ADDENDUM NUMBER: TWO

PROJECT: New Facility For
North Granville County Senior Center

PROJECT NO: 22042

DATE: March 13, 2024

| Sheet Title BULLETIN DRAWING | |

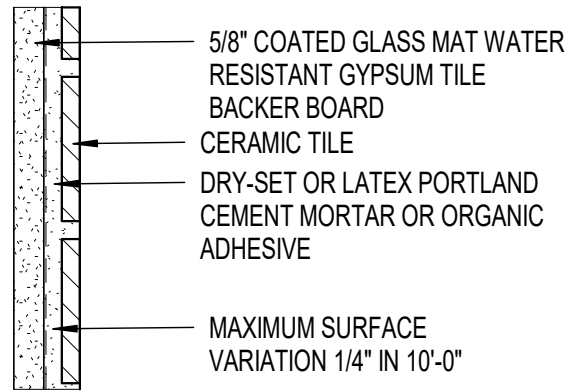
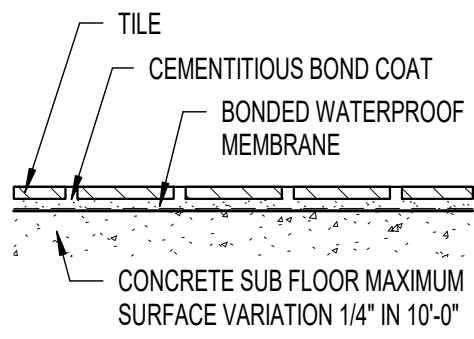
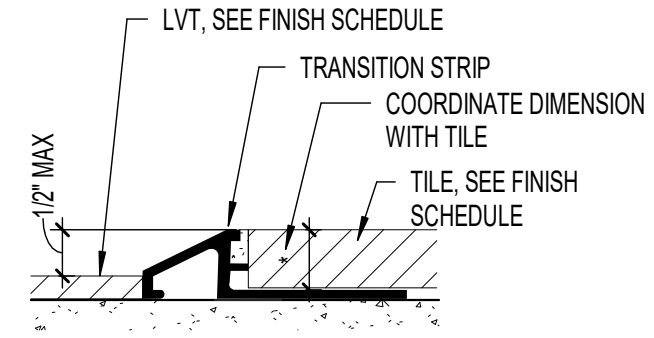
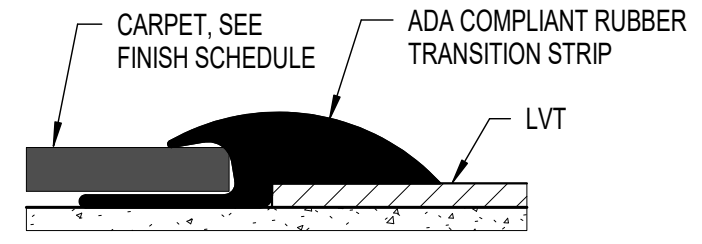
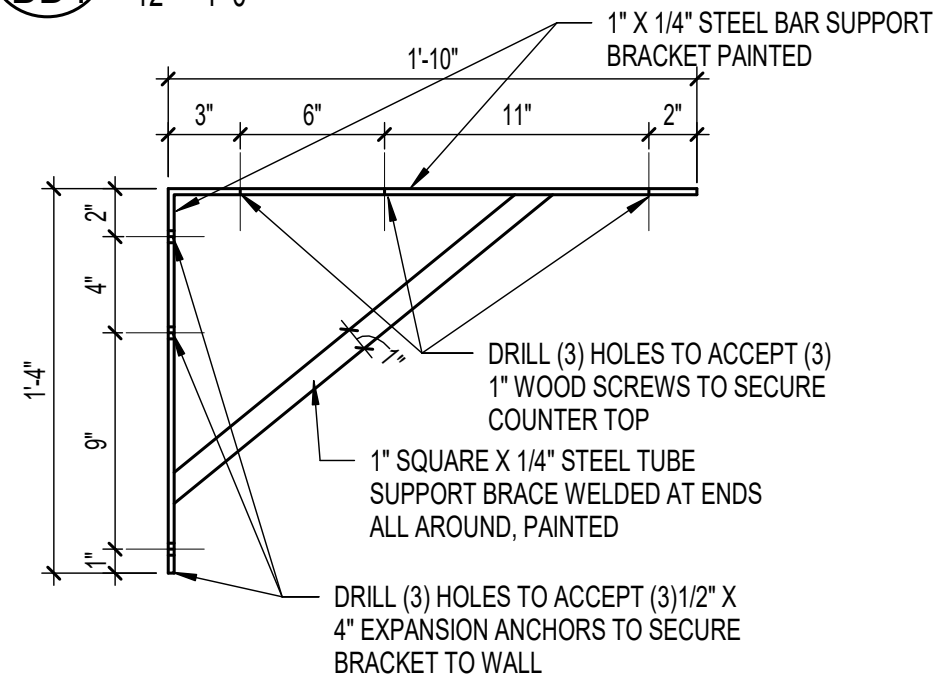
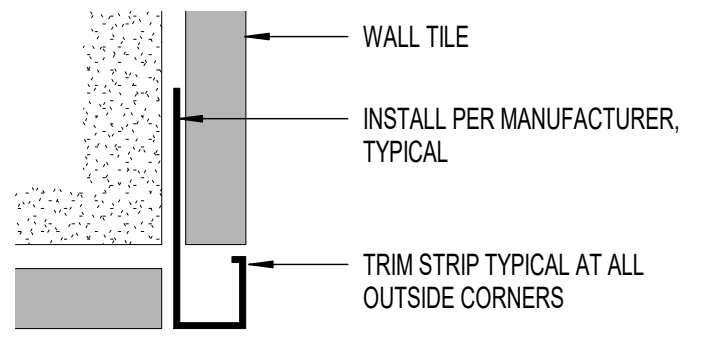
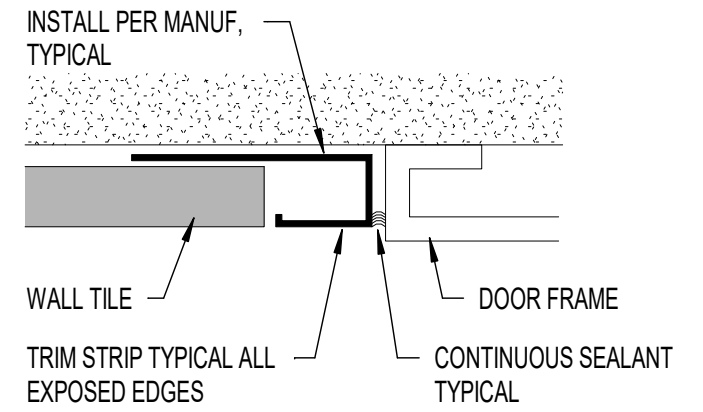
- Item 13 Clarification** **Sheet A1.7 – Finish Plan**
Countertop shown at the end of Hall 111 shall be a 2'-0" Solid Surface countertop supported by Medium Brackets as detailed in Bulletin Drawing attached to this addendum. Coordinated precise extents of countertop with copy machine in field.

NOTE:
TYPICAL TILE EXPOSED EDGE AT ALL GANG TOILET LOCATIONS.

NOTE:
TYPICAL TILE OUTSIDE CORNER AT ALL GANG TOILET LOCATIONS.

NOTE:
TYPICAL TILE EDGE JOINT ABUTTING DOOR FRAMES AT ALL GANG TOILET LOCATIONS.

| BULLETIN DRAWING | |

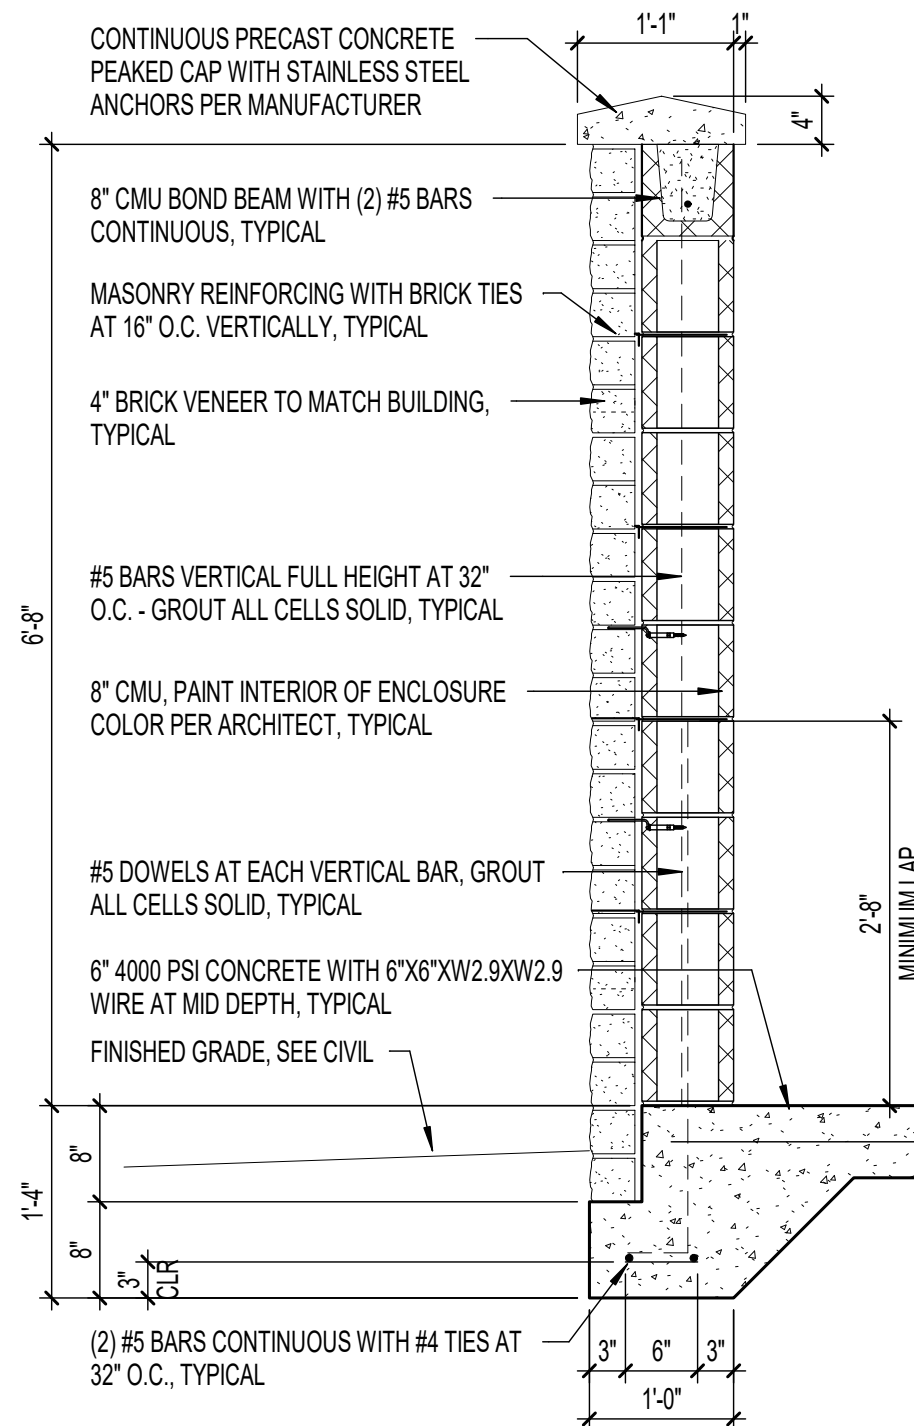
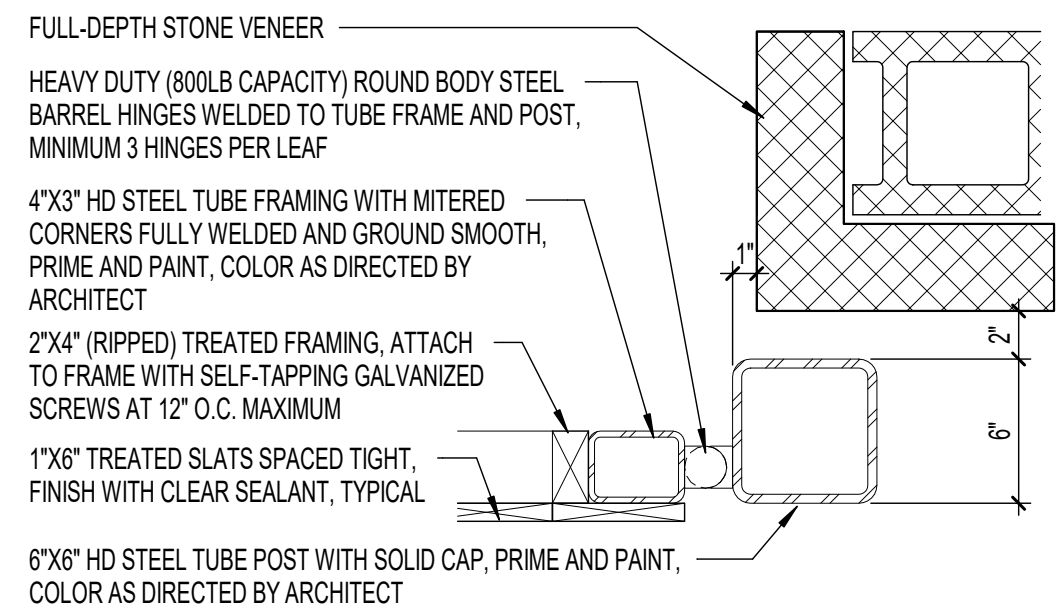
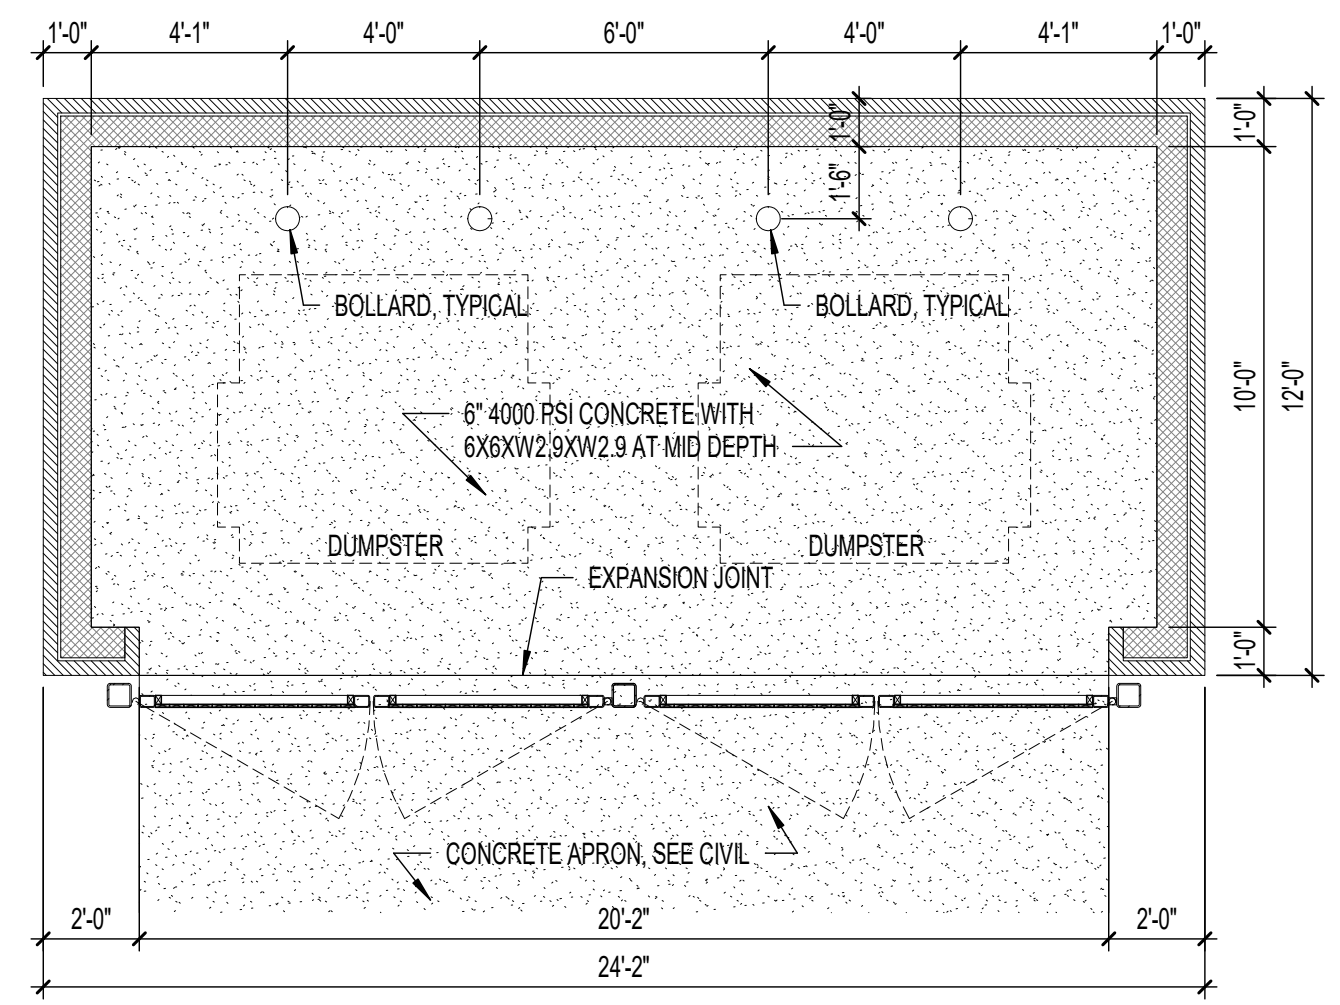
- Item 9 Remove** **Sheet CE-03 – Drainage and Grading Plan**
The stair symbol adjacent to trash enclosure shall be removed in its entirety.
- Item 10 Remove** **Sheet D-06 – Site Details**
Vehicular gate detail shall be removed in its entirety.
